**CABINET MEMBER FOR ENVIRONMENT –15 NOVEMBER 2018**  
**OXFORD - VARIOUS LOCATIONS - PROPOSED AMENDMENTS TO**  
**PARKING AND LOADING PLACES**

**Report by Director for Structure Operations**

PROPOSED AMENDMENTS  
TO LOADING AND TAXI PROVISION

HIGH STREET  
OXFORD

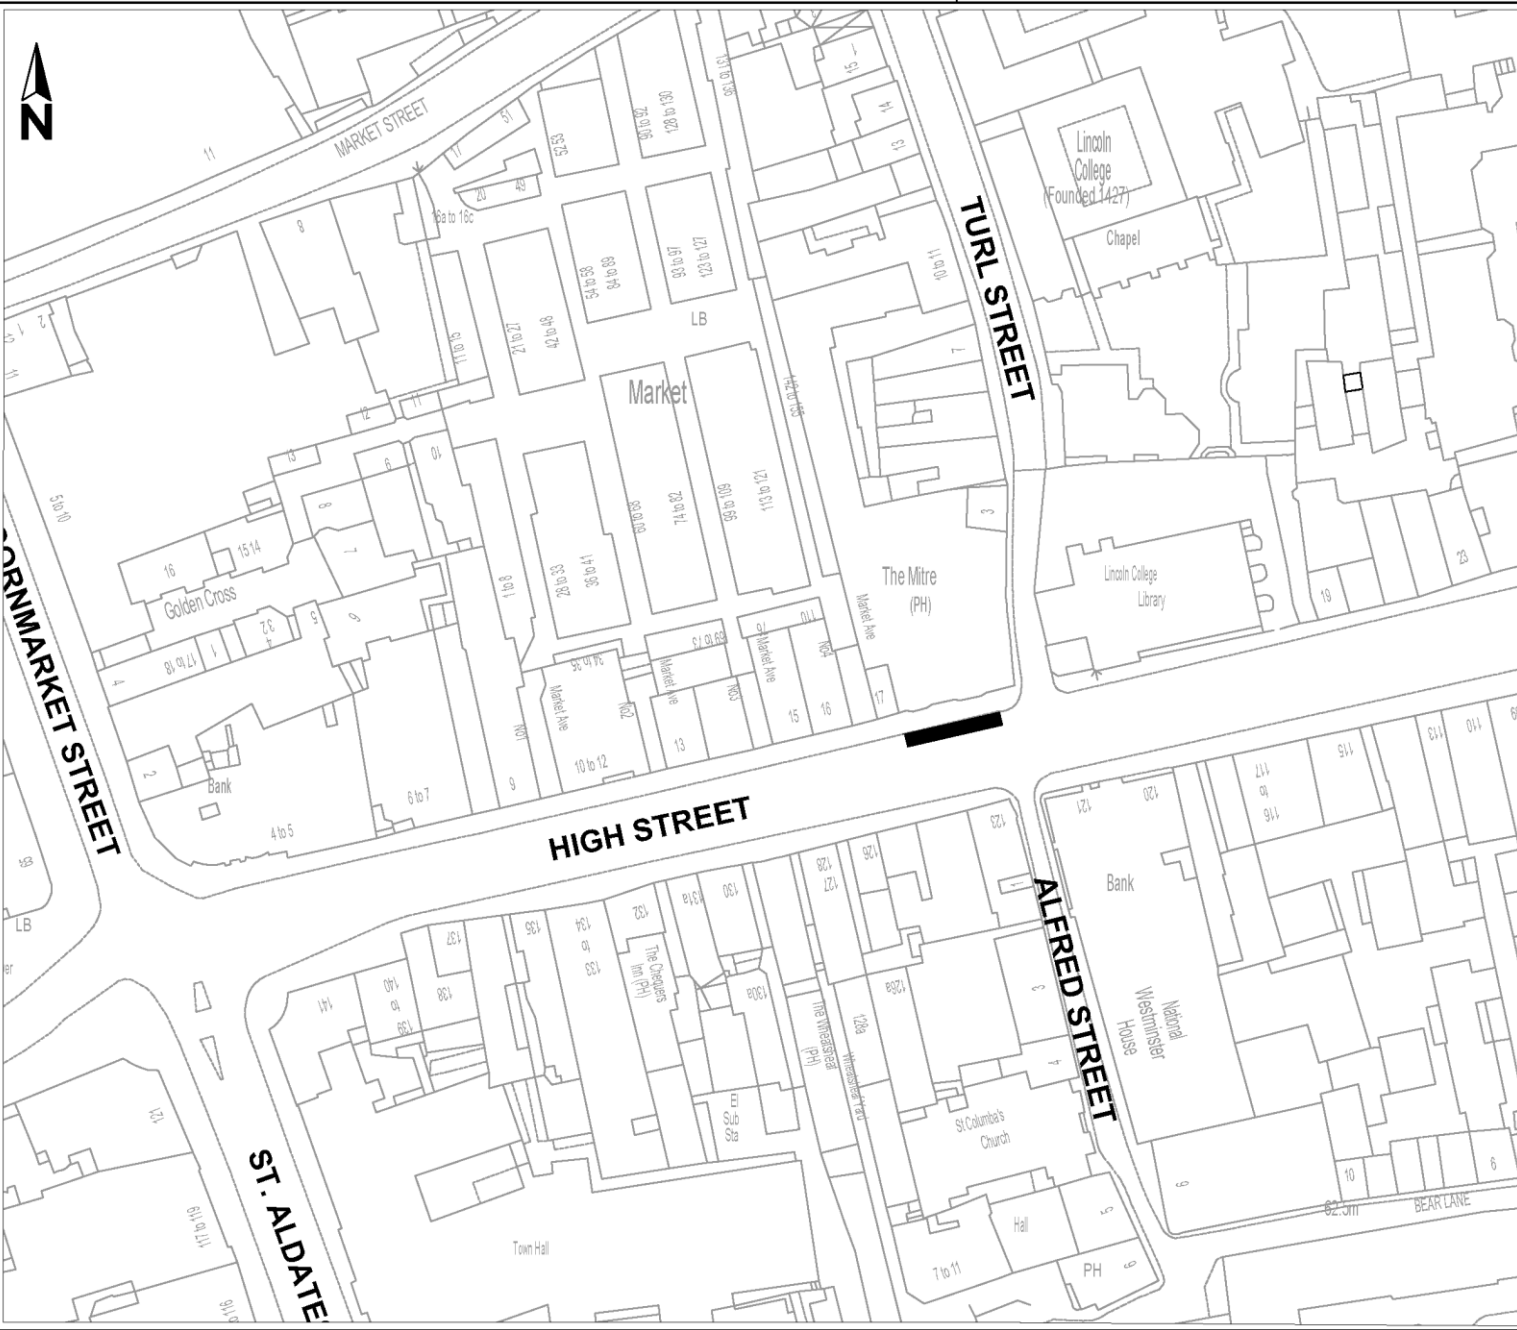
(8) Local Business, (Oxford)	<p><u>New Road</u> - <b>Neither</b> - <i>No comment</i></p> <p><u>High Street</u> - <b>Object</b> - As a business in The Covered Market, we require access for loading and unloading of vehicles on multiple occasions throughout the day as follows:-</p>	To re-provide a taxi rank outside The Mitre, a short single loading bay is proposed to be removed in that location. However, a section of around 20m of kerb on the south side just east of Alfred Street where the existing taxi rank is to be removed would be freed up for loading from 8pm until 12pm as a result of these proposals.

To be clear, the rank proposed outside the Mitre is not in addition to the existing rank on the South side; rather, it would replace it.

<p>(10) Local Business, (Oxford)</p>	<p><u>New Road</u> - <b>Neither</b> - <i>No comment</i></p> <p><u>High Street</u> - <b>Object</b> - As I am sure you are aware, Oxford County Council is already proposing a Zero Emissions Zone in Market Street (where our business is located) to commence by 2020. This will massively impact the viability of businesses in the Covered Market due to restrictive access for our customers, suppliers, our own delivery vans and external contractors. One of the alternatives our business and other traders have looked in to and have discussed with representatives of Oxfordshire County Council, is to use the High Street loading bays as a short-term solution until electric vehicles (both for the public and businesses) are more proven in terms of range, cost effectiveness and the appropriate infrastructure is in place. Oxford County Council is now proposing to remove one or more of these bays. This means there will already be increased pressure on the remaining bays if and when the ZEZ is introduced.</p>	<p>To re-provide a taxi rank outside The Mitre, a short single loading bay is proposed to be removed in that location. However, a section of around 20m of kerb on the south side just east of Alfred Street where the existing taxi rank is to be removed would be freed up for loading from 8pm until 12pm as a result of these proposals.</p> <p>To be clear, the rank proposed outside the Mitre is not in addition to the existing rank on the South side; rather, it would replace it.</p> <p>There will be further, separate consultation on the proposals for a city centre Zero Emission Zone (ZEZ). If the taxi rank and loading arrangements on High Street that are the subject of this report are approved, that will be taken into account in the ZEZ proposals and consultation.</p>

<p>(14) Local Business, (Oxford)</p>	<p><u>New Road</u> – <b>No opinion</b> - <i>No comment</i></p> <p><u>High Street</u> - <b>Object</b> - As a retail business operating in close proximity to Turl St (directly opposite Lincoln College Library) I wish to object to the removal of the nearby loading bay to our premises. We have daily deliveries and collections of goods to and from our premises twice per day. The Oxford University Press Post Room van driver depends on the ability to park nearby to unload and load boxes of books. There are a significant number of retail and food beverage businesses operating on this part of the High st that all share the same delivery bay.</p> <p>Your proposal to remove the loading bay nearest our premises is unreasonable without offering an alternative location for the loading bay so that we can all continue to trade and our delivery drivers can conduct their work safely without conflict with the buses and other road users.</p> <p>I would also like to point out that there is a 3 car-length taxi rank directly outside of the Oxford University Press Bookshop which is never used by any taxi company during our working day, I cannot understand the requirement or justification for a second taxi rank less than 50 yards from the current one on the opposite side of the road.</p> <p>The best public transport solution would be to reinstate all of the previous bus stops on the High st that were removed to drive footfall into the Westgate, this would be a much better use of the existing space and has the advantage of having been successful in the past.</p> <p><u>Little Clarendon Street</u> – <b>No opinion</b> - <i>No comment</i></p>	<p>To re-provide a taxi rank outside The Mitre, a short single loading bay is proposed to be removed in that location. However, a section of around 20m of kerb on the south side just east of Alfred Street where the existing taxi rank is to be removed would be freed up for loading from 8pm until 12pm as a result of these proposals.</p> <p>To be clear, the rank proposed outside the Mitre is not in addition to the existing rank on the South side; rather, it would replace it.</p>

<p><u>High Street</u> – <b>No objection</b> - As a business on the High Street, we have no objection to the specific suggestion to change the loading bay in front of The Mitre to a taxi rank. In fact, it would be an improvement.</p> <p>But can we make the general point that the level of heavy traffic on the High Street has become way too much in recent years. Be careful about encouraging yet more taxis, all the more so since they are usually diesels. On other roads we are often puzzled about why these private chauffeured cars are allowed privileged access to such things as bus lanes, where they significantly add to the hazard of cycling. N2O gases from diesels are almost certainly poisoning our children, or indeed anyone with lungs.</p> <p>The High Street is locally referred to as “Stalingrad”, on account of the number of heavy diesels rumbling over the kerbs and crushing the infantry. Do we really need double-deckers, which weigh about the same as a T34, in this little city? Florence and Sienna, for example, use electric mini-buses in their city centres. The High Street here is very off-putting for cyclists and pedestrians, not to say downright dangerous, and woe betide if you are encumbered with a Zimmer frame or a pram. The eighteen-wheel motorway buses cannot make it round the corner from St Aldates without running over the kerbs and orange traffic bollards. Really, they should start from Thornhill, and electric shuttles run up to there.</p> <p>Taxis should be electric or hybrid, and banned from cycle/bus lanes.</p> <p><u>Little Clarendon Street</u> – <b>No opinion</b> - <i>No comment</i></p>

14. The relocation of the taxi rank from the south side of High Street to outside The Mitre will see the reinstatement of double yellow lines on the south side of High Street in place of the existing taxi rank. This is a kerb length of approximately 20m and would be available for loading from 8pm until 12pm. This is a short distance away from the Mitre loading bay. It was previously a bus stop clearway, and was not available for loading activity at any time.

There will be further, separate consultation on the proposals for a city centre Zero Emission Zone (ZEM). If the taxi rank and loading arrangements on High Street that are the subject of this report are approved, that will be taken into account in the ZEM proposals and consultation.

Drawing title  
**LITTLE CLARENDON STREET OXFORD**

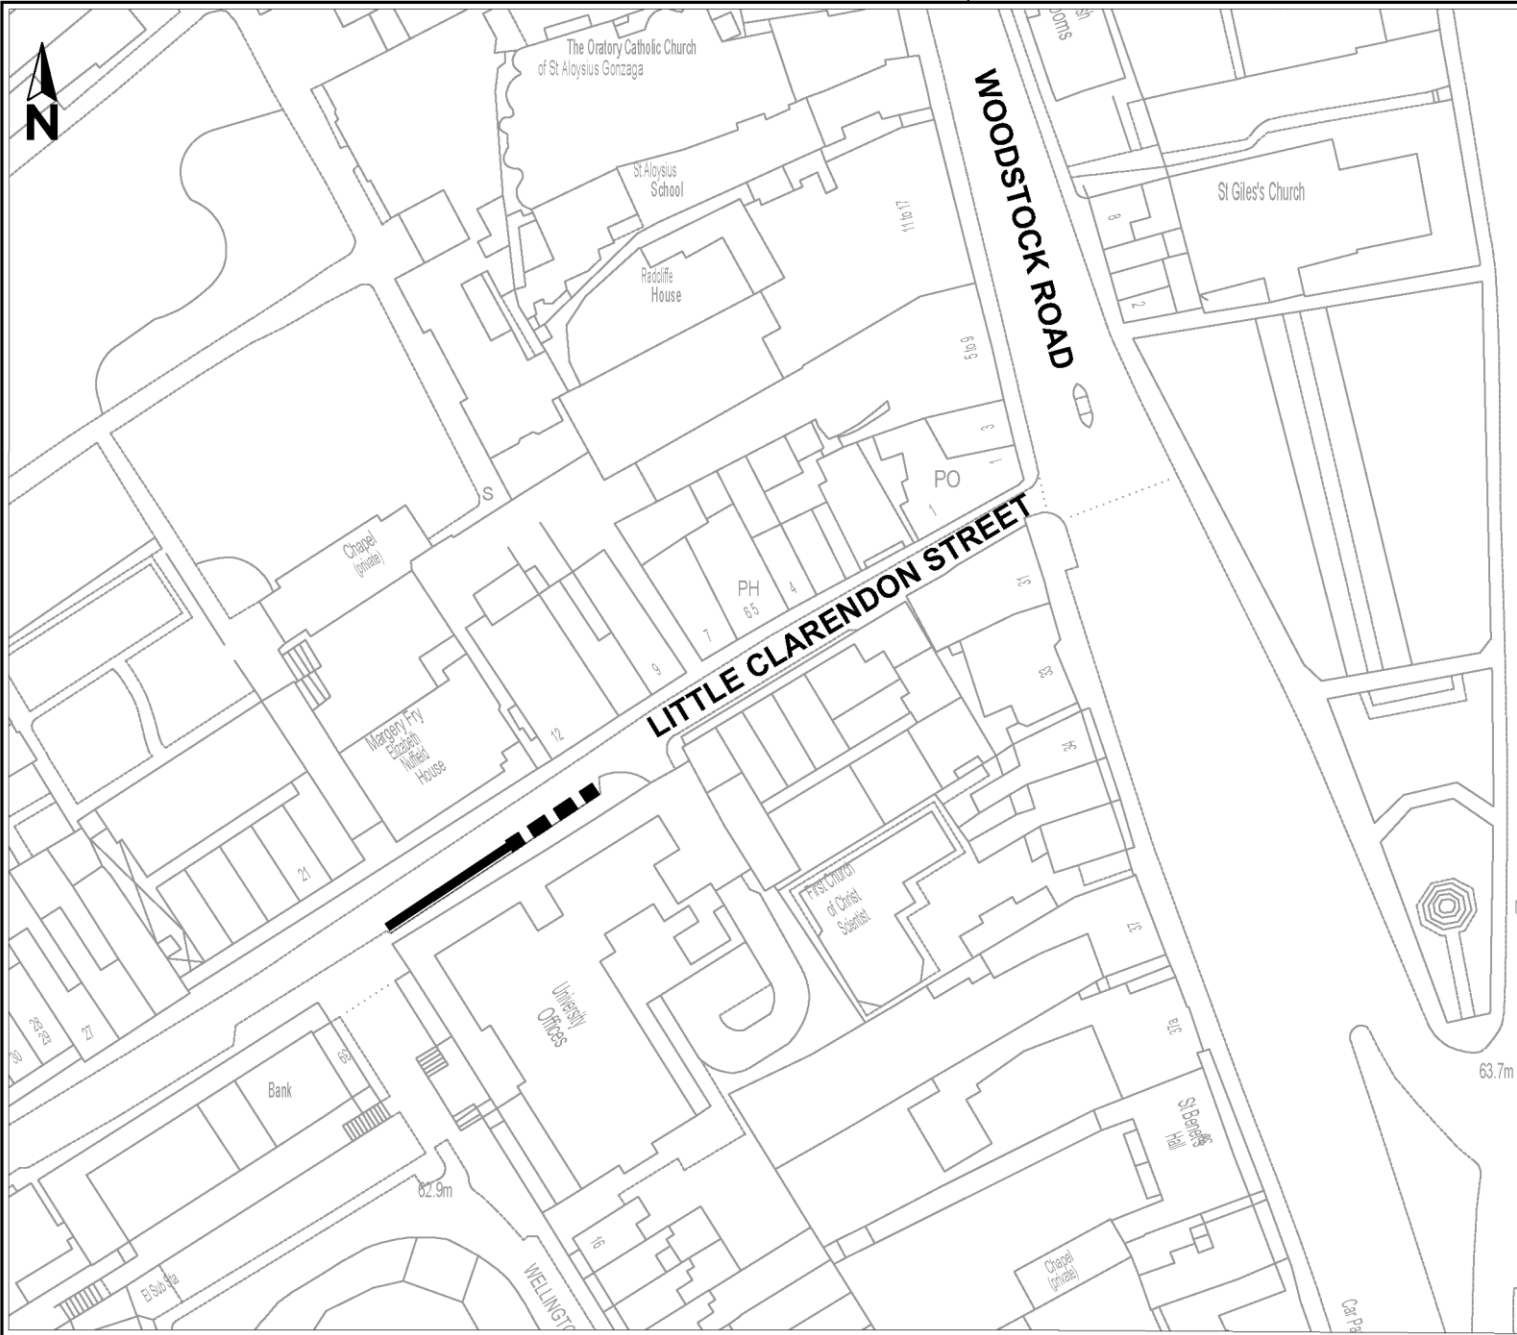
<p>(9) Local Group/Organisation, (Oxford)</p>	<p><u>New Road</u> - <b>No opinion</b> - <i>No comment</i></p> <p><u>High Street</u> - <b>No opinion</b> - <i>No comment</i></p> <p><u>Little Clarendon Street</u> - <b>Neither</b> - The proposal talks of permitting 3 taxi spaces in "the evening", without specifying times. On behalf of local residents, we would not object to provision of a taxi rank until midnight (provided drivers are not permitted to keep their engines running - the street is narrow and fumes would build up rapidly), but would strongly oppose all-night provision which would disturb not only occupants of residential accommodation in Little Clarendon Street itself but also occupants of houses in the surrounding area as lively groups made their way to the rank. If the intention is to cater for Walton Street nightlife, we respectfully suggest that using the public parking spaces outside the Blavatnik and/or Freuds would cause less nuisance to residents.</p>	<p>The proposal is for a taxi rank to be provided for three vehicles for the hours 6.30pm to 8am. Drivers would be required to turn off their engines if they are waiting for any length of time.</p> <p>In order for the taxi rank to be introduced, the city council will need to carry out a separate formal consultation. These issues can be considered as part of that.</p>

<p>(16) Local Business, (Oxford)</p>	<p><u>New Road</u> - <b>No opinion</b> - <i>No comment</i></p> <p><u>High Street</u> - <b>No opinion</b> - <i>No comment</i></p> <p><u>Little Clarendon Street</u> - <b>Object</b> - After 18:30 we may still need to make deliveries to the old Barclays Bank 37-38 Little Clarendon</p>	<p>This proposal does not affect the parking bay closest to number 37-38 Little Clarendon Street.</p> <p>The view of the taxi trade communicated via COLTA is that a rank is needed in this location. The taxi rank provision in St Giles' is not sufficiently close to be convenient for most people visiting Little</p>

<p>Street. This area lacks secure cycle parking, so by preference it would be better to add more cycle parking than additional space for taxis. People expect to get a taxi from St. Giles. Many taxi drivers are in the habit of leaving their engines running which is damaging to the air quality of our outlet, the graduate accommodation above, and the climate in general. There is the potential for noise "pollution" to the graduate accommodation.</p> <p>I would have no objection to the first three spaces, below Central Living's retail outlet, being earmarked for taxis.</p>	<p>Clarendon Street and the close vicinity.</p> <p>The city council has powers to fine drivers who unnecessarily leave their engines idling.</p> <p>This proposal is not reducing the amount of cycle parking. In this area, there are very limited opportunities to provide additional cycle parking on highway land. However, these comments are noted and suggestions for additional provision are welcomed.</p>

17. These issues will need to be considered by the city council in the separate taxi rank consultation it will need to carry out. But in principle, county council officers do not think that the loss of space for 3 car parking spaces between 6.30pm and 8am in this location is sufficient reason not to proceed with further consultation on a taxi rank.

<p>&amp; display parking available in nearby Wellington Square.</p> <p>In order for the taxi rank to be introduced, the city council will need to carry out a separate formal consultation. These issues can be considered as part of that.</p>
<p>(12) Local Business, (Oxford)</p>	<p><u>New Road</u> - <b>No opinion</b> - <i>No comment</i></p> <p><u>High Street</u> - <b>Object</b> - I am writing to object in the strongest possible terms to your proposed amendments to the loading bays on the High Street.</p> <p>The loading bays on the High Street are vital to our struggling business, many if not most of our delivery people use them, preferring the wider space and easier access for their lorries. The Market Street loading area is often/usually congested with smaller vans as there are a lot of businesses based in the market who have or do regular deliveries. That space on its own is wholly inadequate for the needs of the market traders who as whole make a huge financial contribution to OCC coffers.</p> <p>I am surprised that this change has even been considered frankly as anyone with knowledge of Oxford would appreciate the importance of this area to the market traders. If I sound angry that's because I am! Trading in the market often feels like an uphill struggle with our landlord (OCC) continually coming up with new ways to scupper the market. The ill-thought-out Westgate development, the ridiculously expensive parking . . . I could go on.</p> <p>The loading bays on the High St are vital for the market especially if the zero emissions plan goes ahead. Also am I right in thinking that if and when the Jesus College development in Cornmarket goes ahead that Market St will be closed at some point?</p> <p>Please can OCC reconsider this proposal and really think about the needs of OCC's tenants. The Covered Market makes a valuable</p>	<p>To re-provide a taxi rank outside The Mitre, a short single loading bay is proposed to be removed in that location. However, a section of around 20m of kerb on the south side just east of Alfred Street where the existing taxi rank is to be removed would be freed up for loading from 8pm until 12pm as a result of these proposals.</p> <p>To be clear, the rank proposed outside the Mitre is not in addition to the existing rank on the South side; rather, it would replace it.</p> <p>There will be further, separate consultation on the proposals for a city centre Zero Emission Zone (ZEZ). If the taxi rank and loading arrangements on High Street that are the subject of this report are approved, that will be taken into account in the ZEZ proposals and consultation.</p> <p>There are no plans to close Market Street as part of the recently approved Jesus College development.</p>

**Drawing title**  
NEW ROAD OXFORD

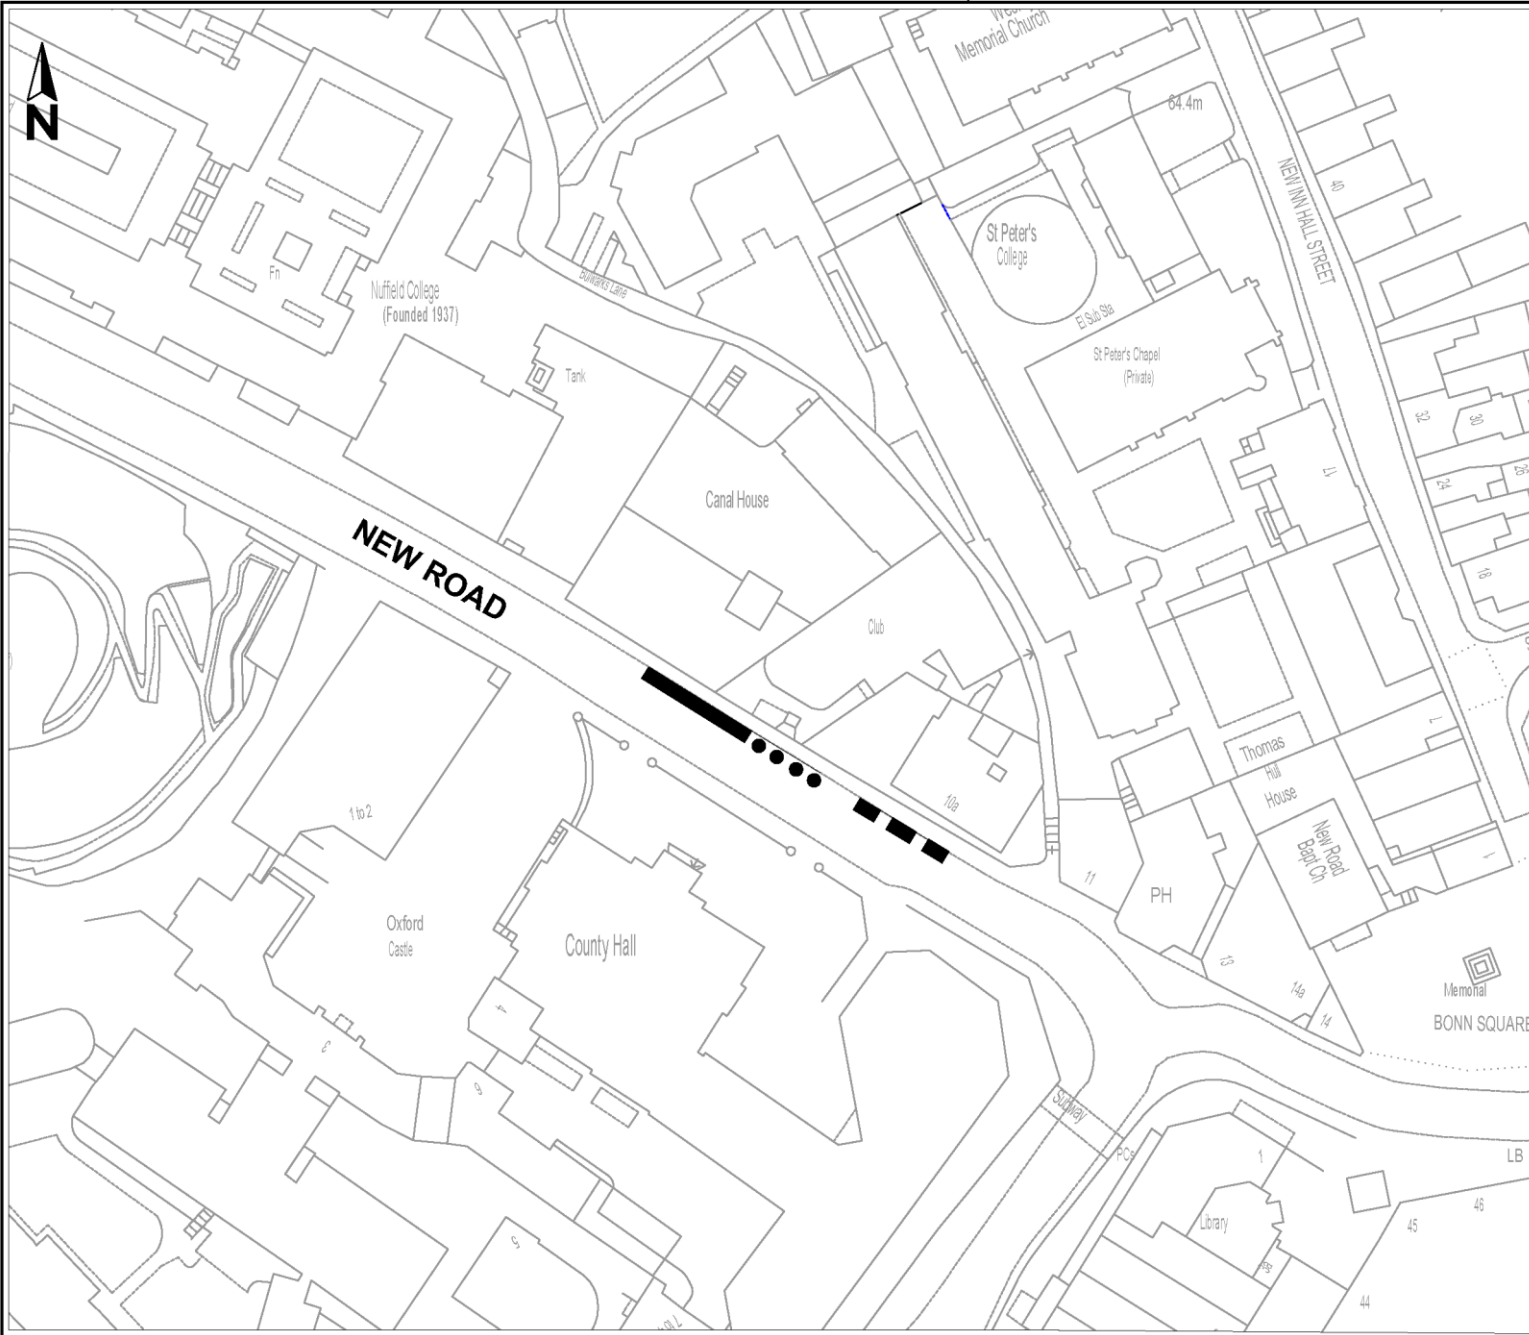
RESPONDENT	SUMMARISED COMMENTS	OFFICER RESPONSE
(1) Traffic Management Officer, (Thames Valley Police)	<b>No objection</b>	
(2) Local Resident, (Oxford)	<p><u>New Road</u> - <b>Support</b> - The Hackney carriage trade of Oxford needs to be accessible to all passengers in and around Oxford city centre. The rank locations proposed are very convenient for everyone to hire a cab from.</p> <p><u>High Street</u> - <b>Support</b> - There was a taxi rank there before. It was very convenient to hire a taxi during the daytime. The rank should be reinstated by removing the loading bay.</p> <p><u>Little Clarendon Street</u> - <b>Support</b> - I'm in support of the taxi rank in Little Clarendon Street. It gives passengers choice to hire a cab from an area which is normally difficult to get a cab from.</p>	Noted

(7) Local Resident, (Oxford)	<p><u>New Road</u> - <b>Support</b> - We do need taxi ranks in city centre.</p> <p><u>High Street</u> - <b>Support</b> - We need same taxi rank located on the high street at the corner of Turl street.</p> <p><u>Little Clarendon Street</u> - <b>Support</b> - The little Clarendon street is busy all day and especially during the evening so I support the taxi rank.</p>	Noted
